REFINERIA DI KORSOU TECHNICAL AUDIT REPORT

Management of the Multidisciplinary Project Team (MDPT) and Refineria di Korsu (RdK) have approached E&D Technologies LLC (E&D) with a request to carry out a technical audit of the a portion of the refinery to assist them with future business decision about the refinery. The objective of the audit has been to provide Refineria di Korsou N.V. (RdK), the owner of the Curacao's Isla Refinery, with a general overview of the plant stationary equipment condition by conducting technical audit of the refinery.

Figure 2.4 Operating Limits for Steels in Hydrogen Service to Avoid High Temperature Hydrogen Attack

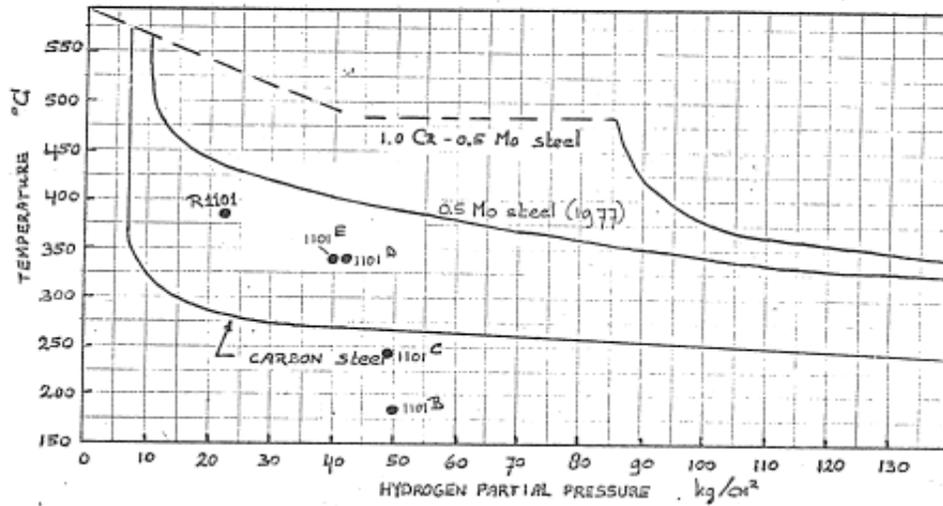
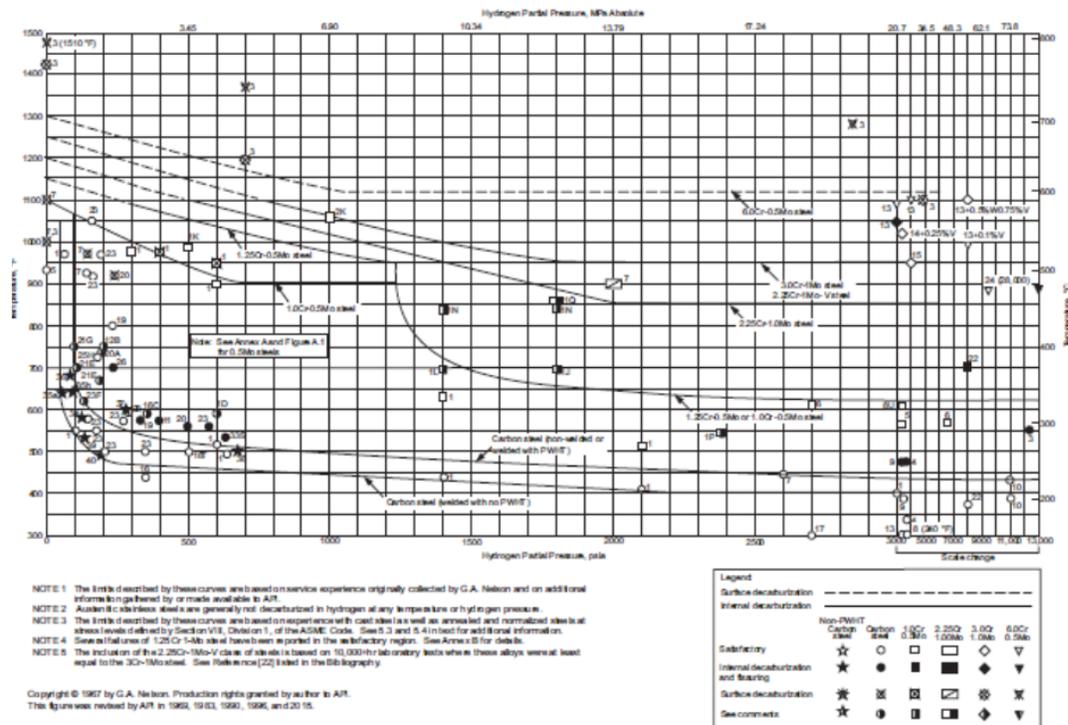
The second major threat may be also the risk of HTHA at the hot end of the Feed/Effluent exchanger E1101 bank, shells D and E, which are also made of C-0.5Mo. These units have been identified as operating above the CS line, which also represents the C-0.5Mo material, Fig. 2.3 originates from RDK/ISLA files. Lowering of the Nelson curve may bring the E-1101-C into the non-recommended zone if some non-PWHT welds (new or repairs) have been installed. The same argument concerning material testing as the one indicated for the R-1101 case applies for the hot components of these exchangers. Due to the lower thickness of the components and gradually lowering temperature gradient the probability and of damage may be somewhat less compared to the Reactor. This, however, would not eliminate the need to address this potential issue.

For comparison the latest curves from API RP 941 are shown below in Fig. 2.4. The drop of the curve for non-PWHT CS may result in inclusion of equipment, which has been considered in the past to be operated in a “safe zone”.

Figure 5.2 Operating limits for steels in hydrogen service to avoid HTHA (ref. API RP 941 Figure 1)

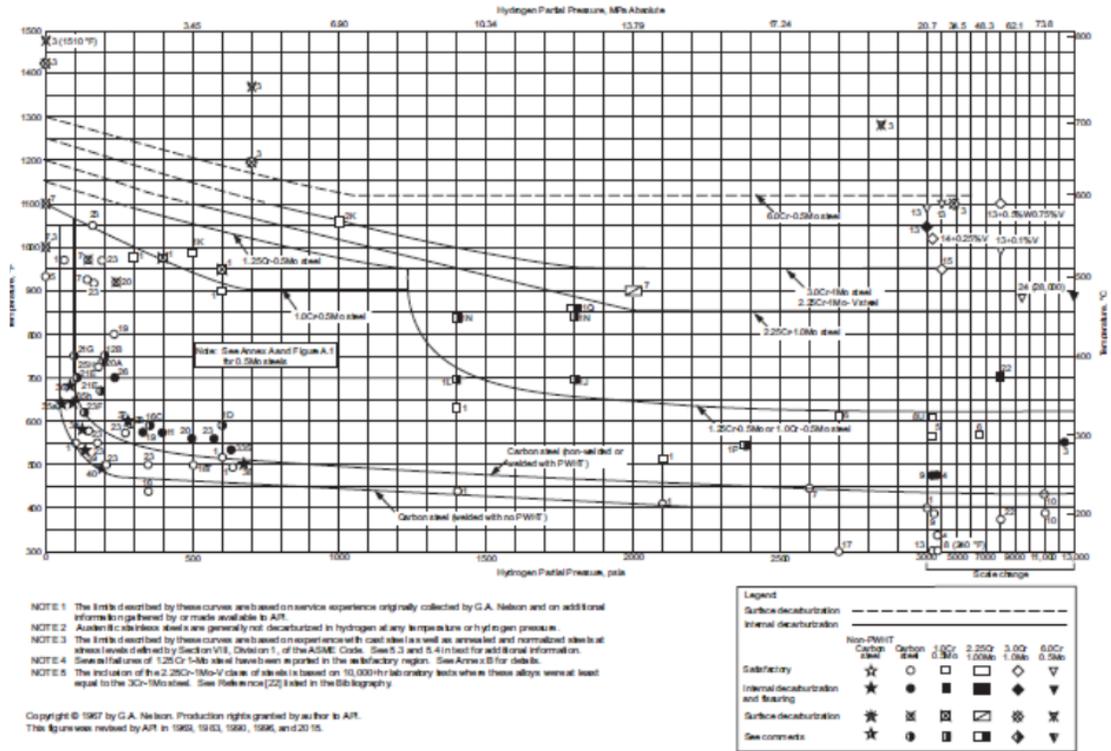
Also, the channel head for E-1306, the hottest Feed to Effluent Exchanger, may be susceptible to HTHA (High Temperature Hydrogen Attack). The conditions on the PFD show a reactor outlet temperature of $380^\circ C$ at 22 BARG. Assuming a H_2 partial pressure of 75% (18 BARG), this means that the head operates approximately $65^\circ C$ above the current carbon steel Nelson curve for PWHT carbon steel (the curve currently recommended

Figure 6.1 Targets for ammonium bisulfide corrosive parameters, acceptable corrosion rates

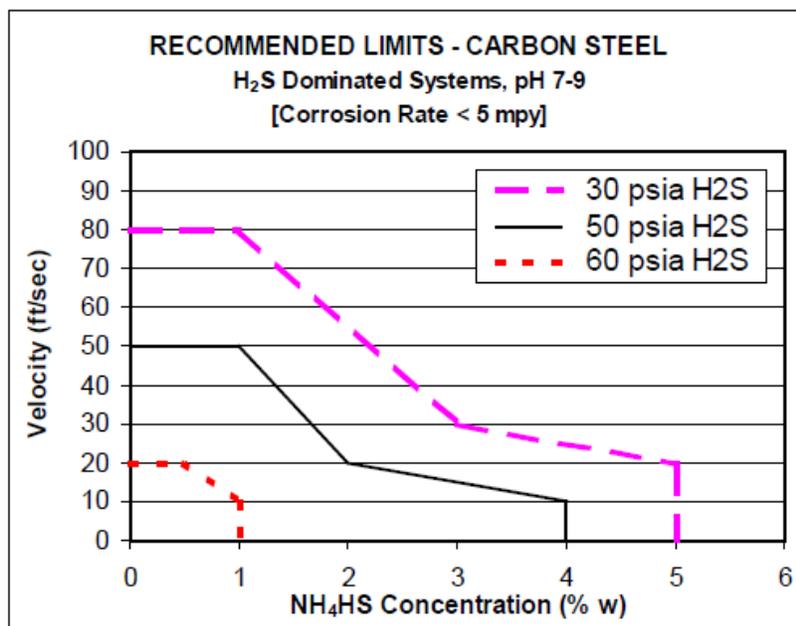
First integrity risk could be the condition of the cold end of the REACS (Reactor Effluent Air Coolers) E1502. Corrosion is not well controlled nor the inspection program able to assess their condition adequately. REAC

corrosion is a weak spot of most hydrocracking units and should be receiving close attention. Corrosion in these systems can be localized and at times severe. The most frequent damage is caused by Ammonium Chloride salt deposits or Ammonium Bi-sulfide in high velocity and turbulence areas. Numerous failures have occurred in these REAC systems. Since information on the precursors to the corrosive compounds hasn't been available we could not quantify the corrosion risks. Water wash is commonly utilized to dilute or prevent deposition of the ammonium salts but its effectiveness depends very much on the injection system design and operation and wash water application and quality. Guidelines for design and operation of such systems are available. We did not locate comprehensive design data for this WW system. Example of targets for acceptable corrosion rates are shown below in Fig. 6.1

Figure 2. This is Figure 3.46 of the technical report INT-6024,1999. It shows the evidence of growth measured since 1990. Compared with the 1999 measurements, this represents a maximum of 0.28% growth in 9 years of service, equivalent to 0.031%/year creep rate.

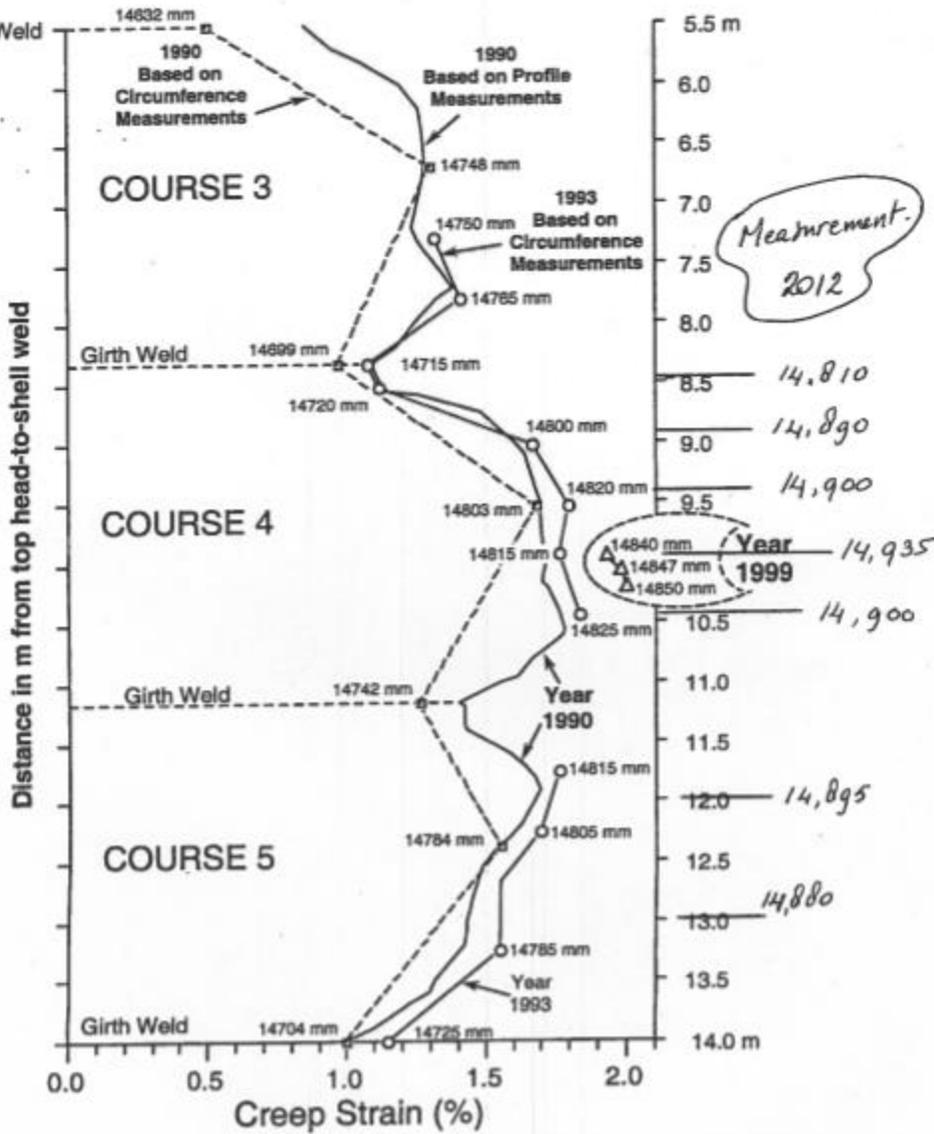
As noted in 1992 Report, the remaining life assessment performed in 1989-1990 should be invalidated for many reasons noted in the No-92-7349 report. One of the reasons is that the test condition is much higher than the operating condition. In such a case, it will be difficult to estimate reasonable remaining life by extrapolating the Larson-Miller parameter as shown in Figure 1 (Reference API 579 committee work Figure 13.5-2). A great deal of technology progresses have been made since 1991 regarding high temperature life assessment. (ref: Prager, M. "Development of Project Omega Method for the Life Assessment in the Creep Range" ASME PVP, 1994, Kim. DS & Mead, HE "Creep Remaining Life Assessment of Heater Tubes using Omega Method, ASME PVP 1999, API RP 579, 2007). American Petroleum Institute (API) Recommended Practice API RP 579 "Fitness For Service" and ASME "FFS-1" was published to estimate a more accurate remaining life assessment and testing. More realistic remaining life assessment can be made by utilizing the Omega method. In order to carry out the assessment, actual material data, process temperature and pressure should be given. Since no available data were provided, only sensitivity analyses were made to provide perspectives.
